Service Program Trucks

Timing Gear Plate Screw, Installation VN, VHD, VAH

SP 215-021, Timing Gear Plate Screw, Installation

(April 2017)

W2122412

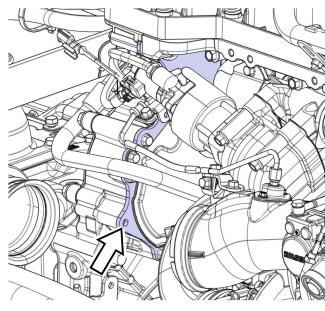
10 Check the screw hole for any silicone or debris and clean as needed.

W2122413

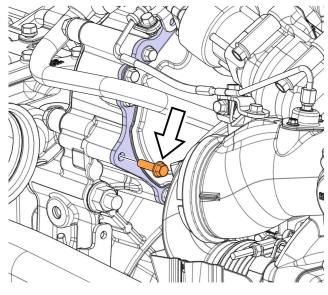
- 11 Install the missing screw in the timing gear plate.
- 12 Tighten the screw to 24 \pm 4 Nm (18 \pm 3 ft-lb).
